# Proposed CR ISI\_RES Spec Change

Mau-Lin Wu, Tobey P.-R. Li  
MediaTek

**For IEEE 802.3ck Ad-Hoc**

# Example of Spec Methodology and Spec Limit

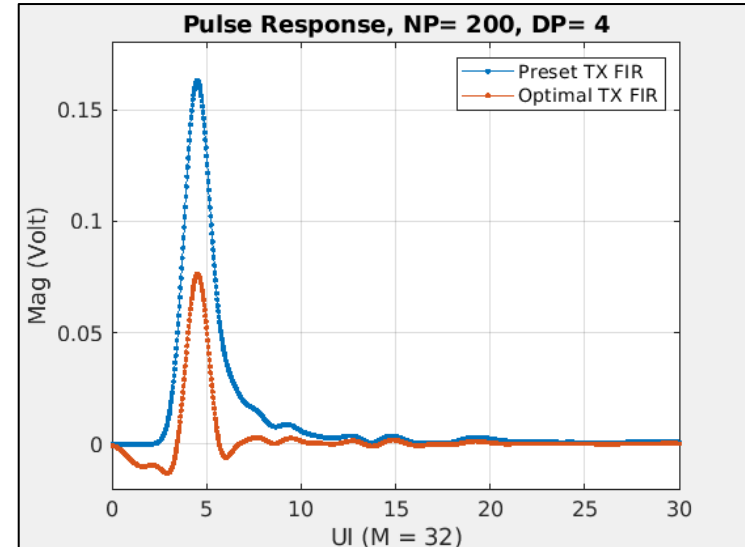
- TX FIR spec (Table 162–10)
  - Max. TX FIR peaking gain: ~11 dB

- TX compliance results

TX FIR Setting	ISI_RES (Np = 11)
Preset 1	[0 0 0 1 0]	-27.10 dB
Optional 3A	[-0.06 0 -0.14 0.6 -0.2]	<b>-29.15 dB</b>

- TX FIR can flatten the “long tail” due to dispersion, although it may cause undershoot just before and after main cursor

\* Take “C2M\_Z100\_IL12\_WC-BOR\_H\_L\_H\_THRU” as example

- Add the following paragraph after the 1st sentence of 163.9.2.6 [Thanks to Adee's contribution]
  - ISI\_RES is calculated from measurements with a single transmit equalizer setting to compensate for the loss of the transmitter package and host channel. The equalizer setting is chosen to minimize ISI\_RES.
- In Table 162-10, change
  - ISI\_RES (max) from -30 dB to -29 dB
